South Texas Project Electric Generating Station P.O. Box 289 Wadsworth, Texas 77483

August 19, 2010  
U7-C-STP-NRC-100193

South Texas Project  
Units 3 and 4  
Docket Nos. 52-012 and 52-013  
Revised Response to Request for Additional Information

**RAI 03.08.04-18, Revision 1, Supplement 1****QUESTION:****Follow-up to Question 03.08.04-2 (RAI 2964)**

FIGURE 1.2-23A RADWASTE BUILDING AT ELEVATION -1700 MM

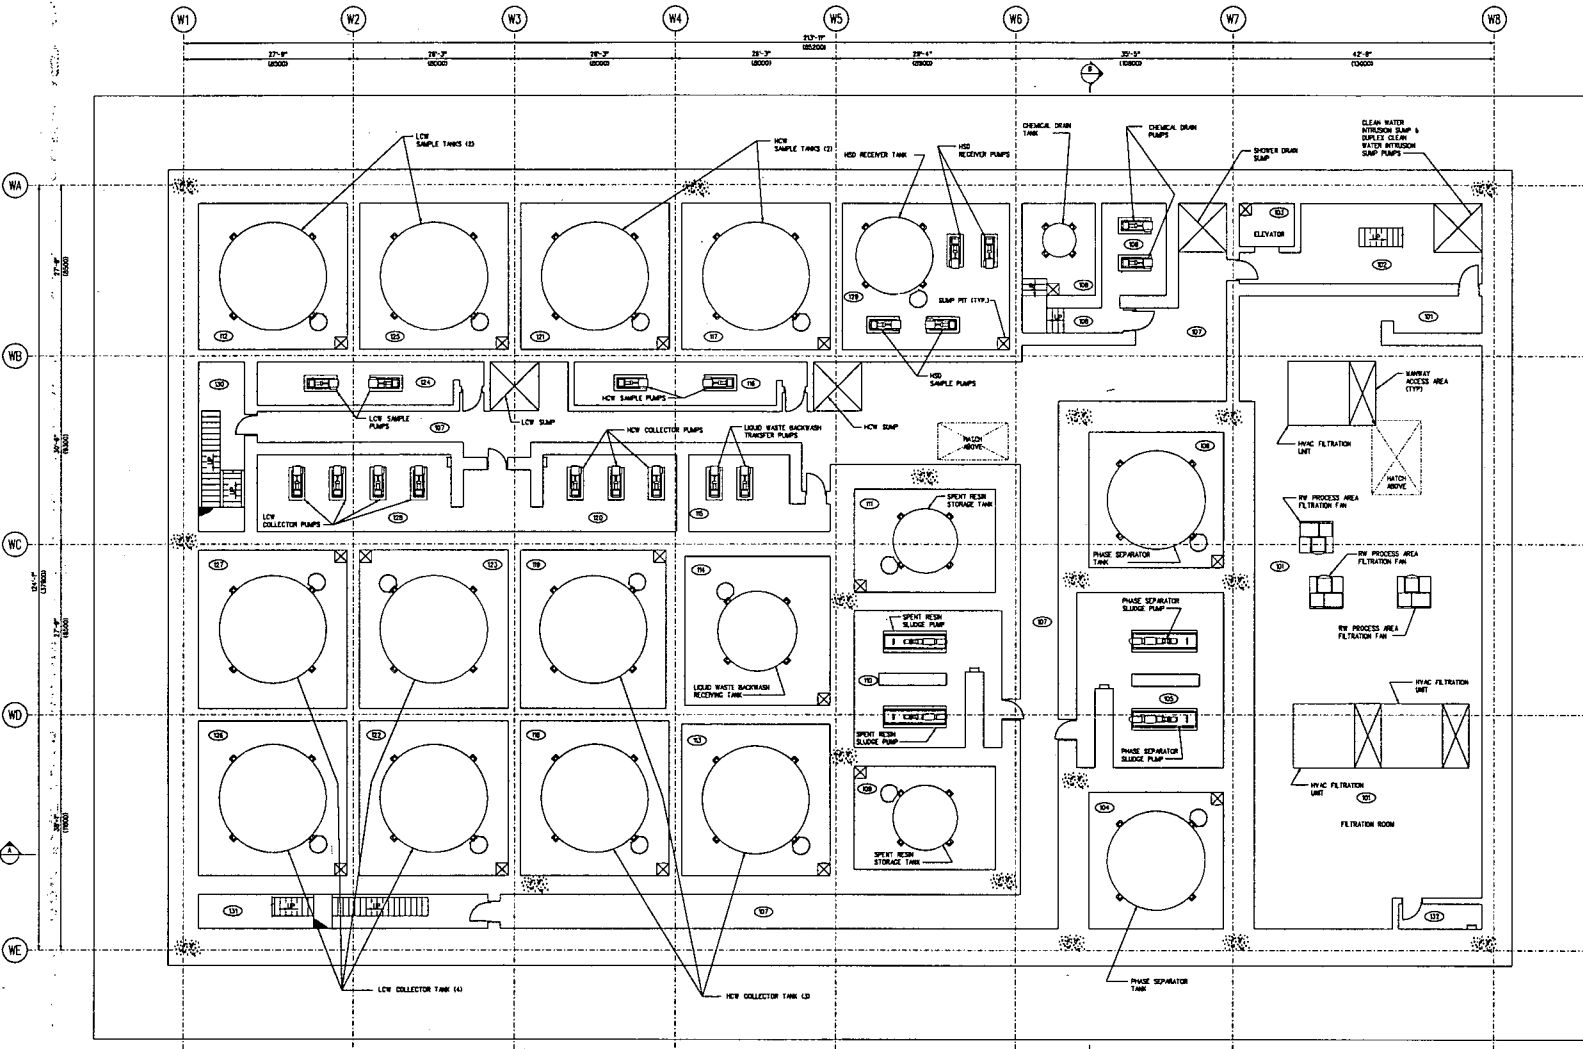
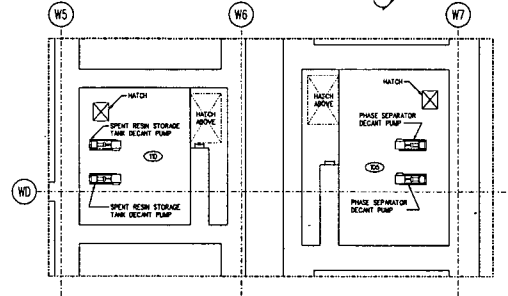
Equipment Arrangement (Figures 1.2-23a and 1.2-23b)

- The phase separator tanks and associated pumps are moved from the west end of the building to the east end. This change shortens the piping runs from the radwaste piping tunnel (which provides the connection to the Reactor Building and Turbine Building) to the tanks and from the tanks to the dewatering equipment. The shorter piping runs for this system, which has a high solids content, reduce demand on components of the system, help prevent crud buildup, and minimize and localize the sources associated with the phase separator tanks.

- The decant pumps for the phase separator and spent resin tanks were separated from the transfer pumps and placed in separate rooms for ALARA purposes (see “Partial Floor Plan” on Figure 1.2-23a). The decant pumps are expected to handle liquid with a much lower activity than the transfer pumps, so this is an implementation of the ALARA concept of separating low activity components from high activity components.

- The two rows of tanks were shifted to the west against the west wall to utilize the space formerly occupied by the phase separator tanks. The corridor along the west wall, which was used to access the phase separator tanks, was eliminated as no longer necessary, and to save space. The removal of the corridor required the addition of a stairwell in the northwest corner of the building for life safety reasons.

- The liquid waste (LW) backwash receiving tank and associated pumps were moved from the northwest corner of the RWB to the approximate center of the RWB adjacent to the west wall of the spent resin tanks. This move also locates this tank near the other sludge tanks so that all sludge tanks are located in the same area of the RWB. This move shortens the pipe runs from the processing equipment located on the floor above, which is the primary input to the tank. This also locates the LW backwash receiving tank closer to the phase separator, which is used to process the contents of the LW backwash receiving tank. In a manner similar to the relocation of the phase separator tank, the shorter piping runs for this system, which has a high solids content, reduce demand on the components of the system, help prevent crud buildup, and minimize and localize the sources associated with the LW backwash receiving tank.

- The row of sample tanks along the north wall was shifted west to the west wall to utilize the space formerly occupied by the LW backwash receiving tank. A wall was added between the two high conductivity waste (HCW) sample tanks to provide shielding between two passive components. This provides shielding that may be required in the unlikely event that one of the HCW sample tanks becomes contaminated to ensure that the radiation zones are not adversely impacted.

- The hot shower drains (HSD) receiver and sample tanks and pumps were moved from the center of the RWB to the north wall east of the sample tanks. This move makes room for the LW backwash receiving tank in the center of the RWB and utilizes space vacated by the relocation of the LW backwash receiving tank. The HSD receiver and sample tanks are low activity tanks, and this move groups them with the low activity sample tanks. Both tanks and the pumps are accessed from El 12'-0", and the lower region serves as a stainless steel lined leak retention space similar to the other tank rooms (this is unchanged from the current design).

- The chemical drain tank and pumps were moved from the second floor (Figure 1.2-23b) to the basement (Figure 1.2-23a) along the north wall east of the HSD tanks. This made use of available space and freed up space for a valve aisle on the second floor (this places the valves and pumps in separate rooms to reduce radiation exposure). When combined with the relocation of the HSD tanks, all low activity tanks are located along the north wall of the RWB (this will facilitate operations and reduce operational radiation doses).

FIGURE 1.2-23B RADWASTE BUILDING AT ELEVATION 5300 MM

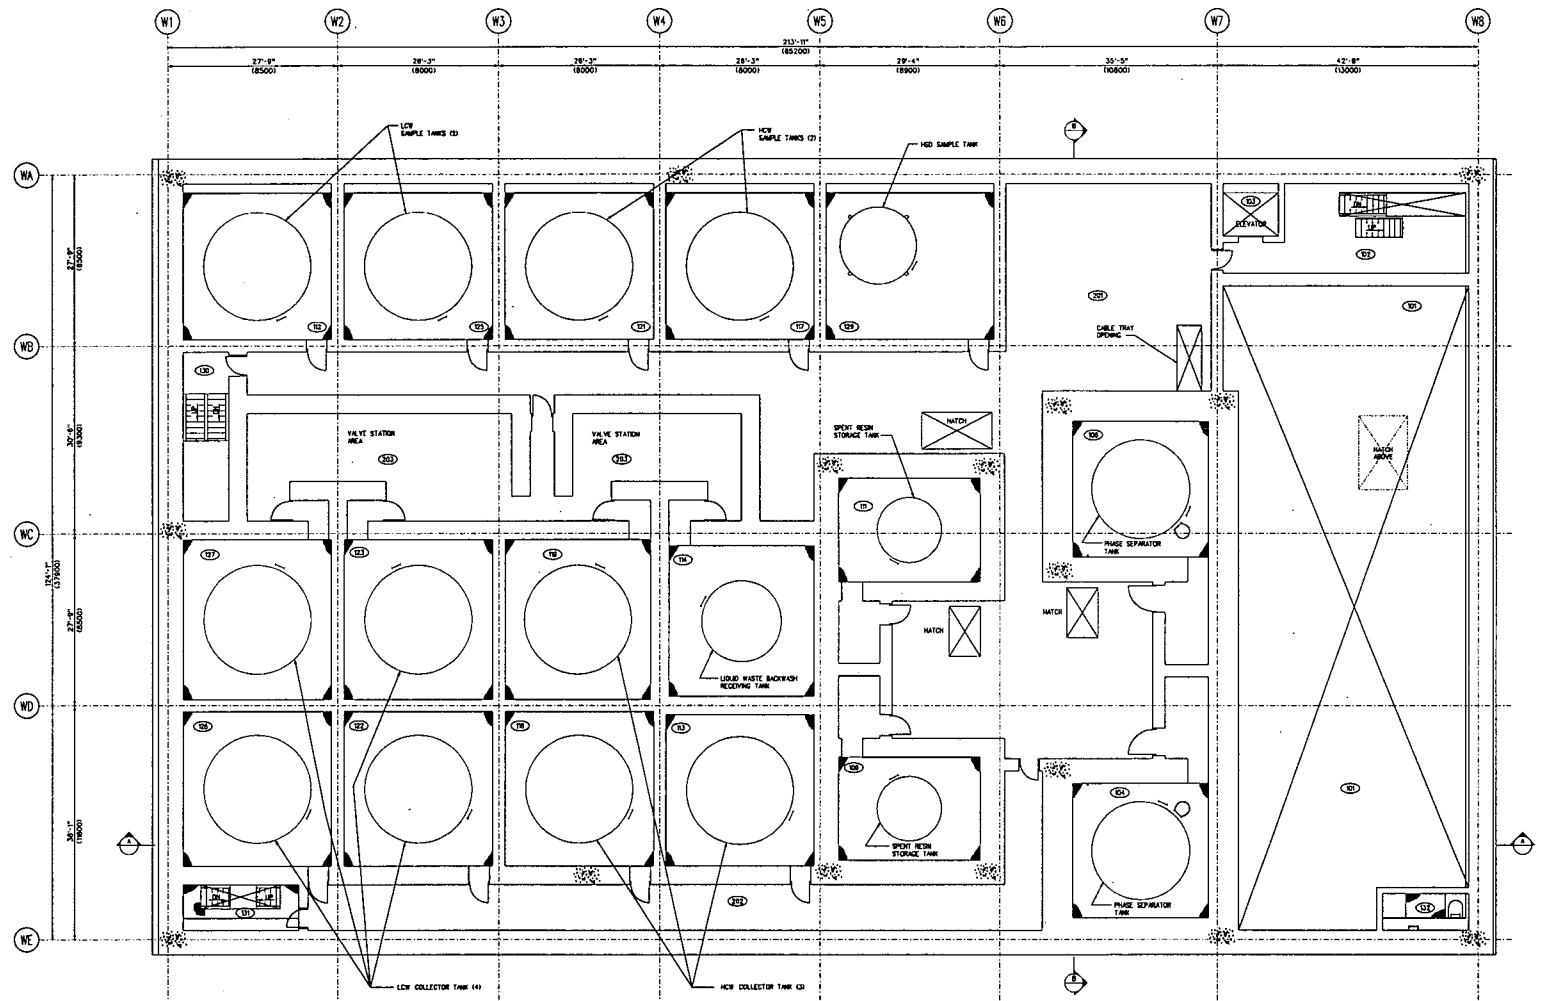
- The electrical equipment room was moved from the El 5300 mm floor (Figure 1.2-23b) to the Grade floor (Figure 1.2-23c) to locate it adjacent to the control room (this places the clean electrical areas in adjacent locations). The area on the El 5300 mm floor is now used as a cable spreading area (this will facilitate construction and maintenance).

FIGURE 1.2-23E RADWASTE BUILDING, SECTIONS A-A, B-B (SHEET 1)

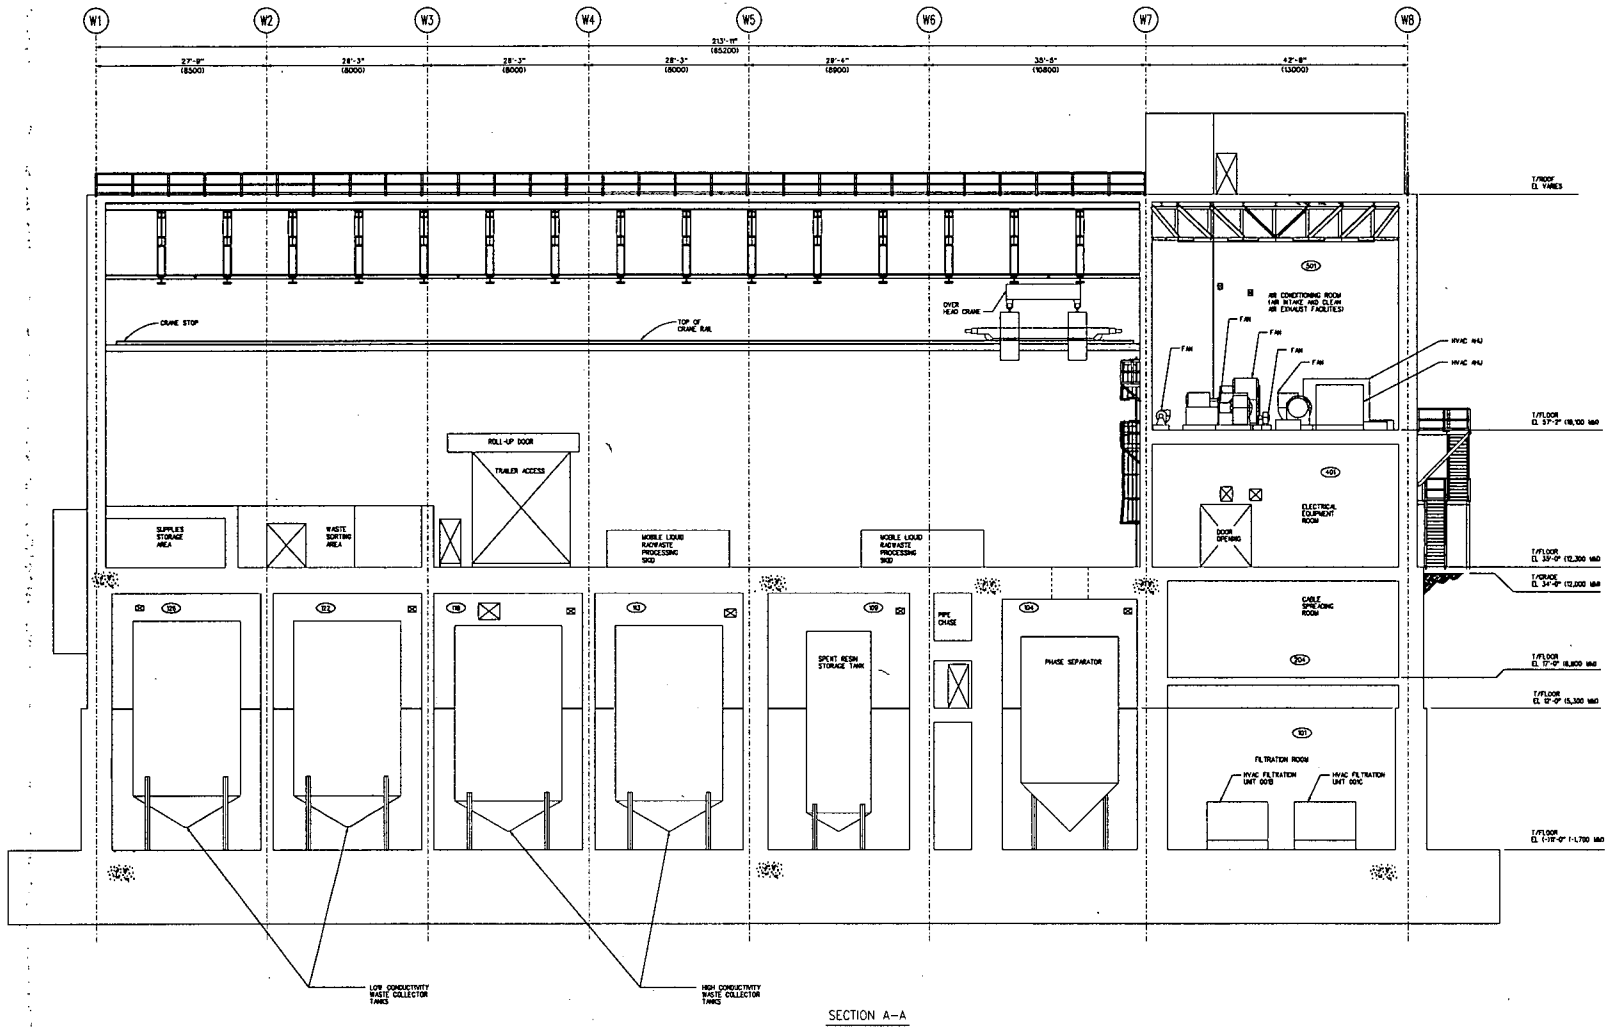
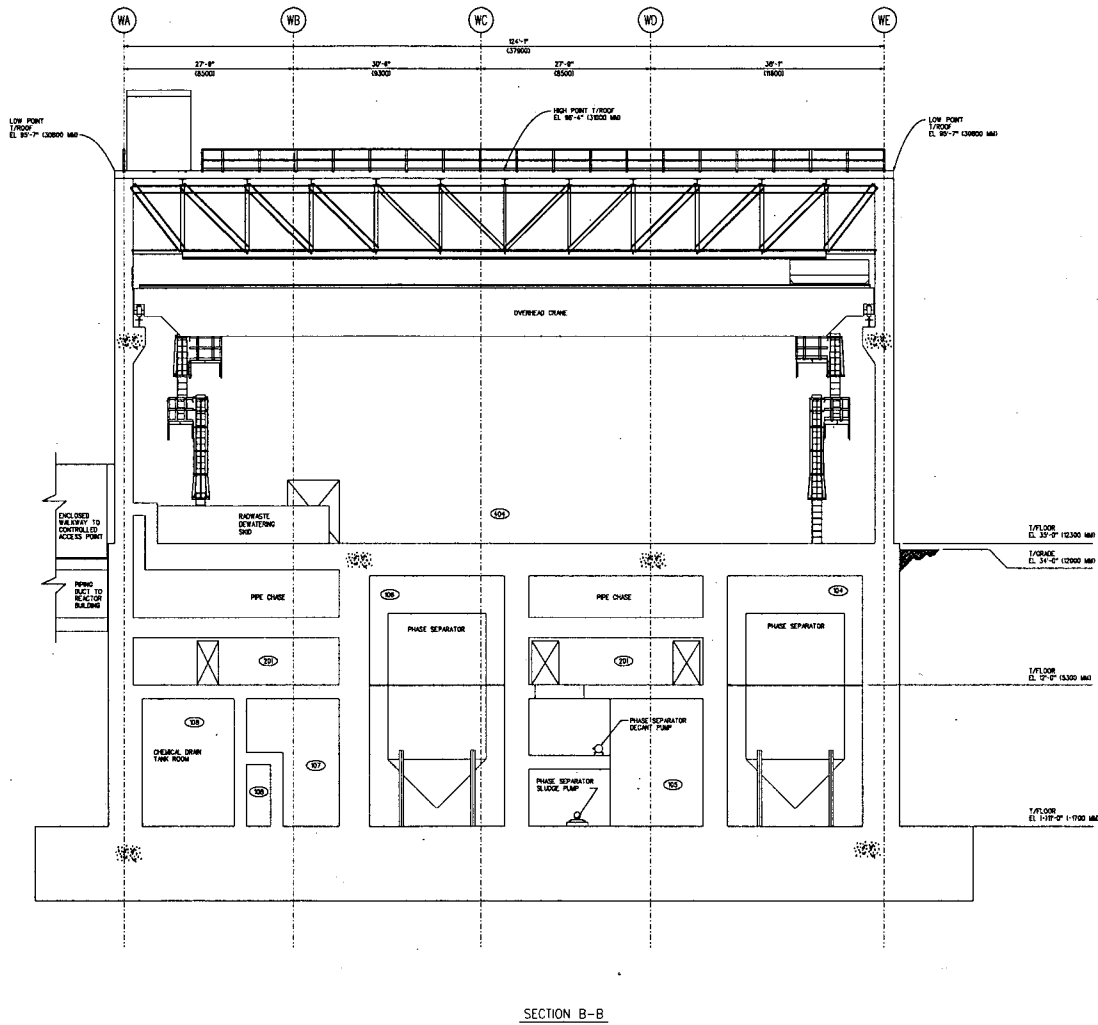
#### Building Size (Figure 1.2-23e)

- The height of the roof above the ground floor has increased from 44'-0" to 61'-4" to accommodate the size and lifting height requirements of the overhead crane. This will improve the operability of the facility (e.g., radioactive waste cask loading operations) by increasing the crane hook clearance.
- The changes in thickness of the RWB outside walls and the configuration of the basemat as shown in the revised Figure 1.2-23e are based on the detailed structural analysis. The interior dimensions of the RWB are not changed.

- The section views on Figure 1.2-23e were separated onto two sheets (maintaining the same figure number) to improve legibility as required for the larger scale used for the revised figures.
